Company	Trenz Electronic GmbH
PCN Number	PCN-20210216
Title	TE0712-02 DDR3, Flash Change and Product Update
Subject	BOM change
Issue Date	2021-02-17

PCN-20210216 TE0712-02 DDR3, Flash Change and Product Update

Locate DDR3 RAM (U15 top, U19 bottom) and Flash (U4 top) on PCB:

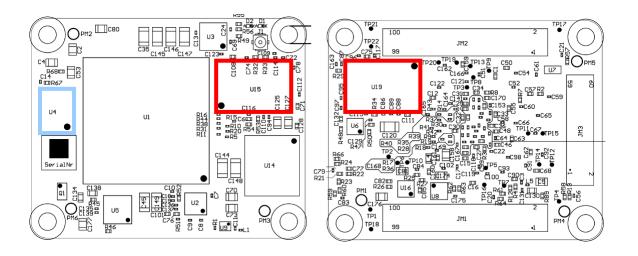
2.1 #1 Change DDR3 RAM (U15, U19) from IM4G16D3FABG-125I to IS43TR16256BL-125KBLI

2.2 #2 Replaced Flash (U4) to IS25LP512M-RHLE

old	new
IM4G16D3FABG-125I	IS43TR16256BL-125KBLI
IM4G16D3F ABG-125I TW KP9006 1927 1901X772104	ISSI 2001 IS43TR16256BL -125KBLI K096 MLP758000Y1 TWN

old	new
S25FL256SAGBHI20 or MT25QL256ABA8E12-1SIT	IS25LP512M-RHLE
TE0712-02-2CA and TE0712-02-72C-03-M only:	ISSI 1932 IS25LP512M -RHLE P1P641B9
